UNITED STATES PATENT AND TRADEMARK OFFICE

APPLICATION NO.	FILING DATE	FIRST NAMED INVENTOR	ATTORNEY DOCKET NO.	CONFIRMATION NO.
10/700,620	11/05/2003	Junichi Noro	02410345AA	4870
30743	7590	06/03/2005	EXAMINER	
WHITHAM, CURTIS & CHRISTOFFERSON, P.C. 11491 SUNSET HILLS ROAD SUITE 340 RESTON, VA 20190			VY, HUNG T	
			ART UNIT	PAPER NUMBER
			2821

Office Action Summary	Application No.	Applicant(s)
	10/700,620	NORO ET AL.
	Examiner	Art Unit
	Hung T. Vy	2821

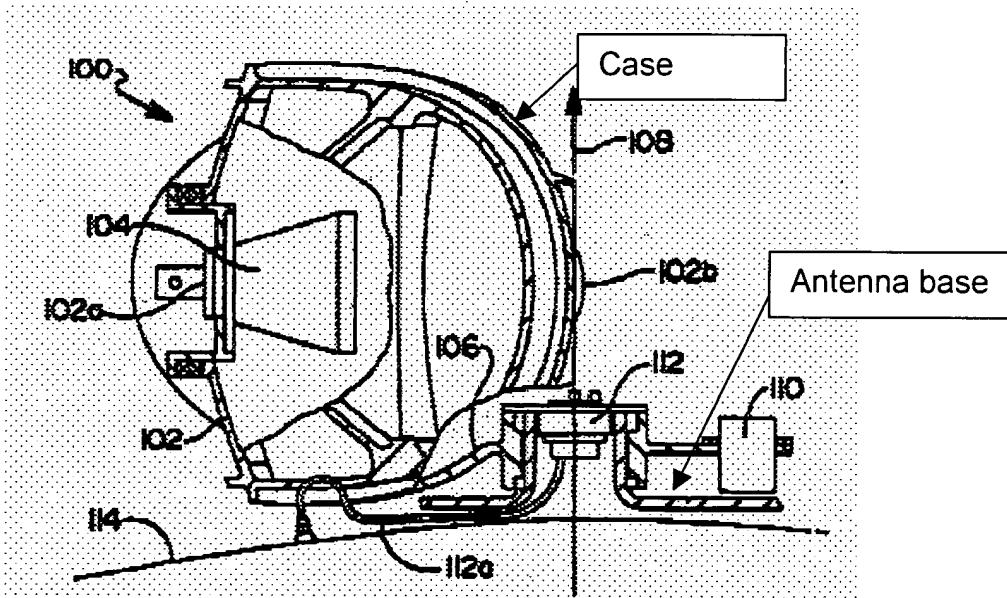
Claim 1, Desargant et al. disclose an antenna apparatus, comprising: an antenna element 102,104, having directivity in a vertex direction; an antenna case 106 (See fig. below), containing the antenna element; an antenna base 112, 110, coupled to the antenna onto an installation face 114; and an angle regulator 103, adjusting a relative antenna case 104 and the antenna base 101 case, and attached angle between the antenna case 106 and the antenna base (See below) to optimize a sensitivity of the antenna element to a received signal.

Claim 12, Desargant et al. disclose the antenna apparatus, comprising: an antenna element 102, 104; an antenna case 106 (See fig. above); an antenna base 112, 110, coupled to the antenna case and attached onto an installation face 114; and a low noise amplifier circuit board 18,20, amplifying a signal received by the antenna element 108,104; wherein the antenna element 108,104 and the low noise amplifier circuit board 18,20 are contained in the antenna case; wherein the antenna base 112,110 is fixed to the installation face 114; and Wherein the antenna case is movable with respect to the antenna base (See column 3, line 10-42).
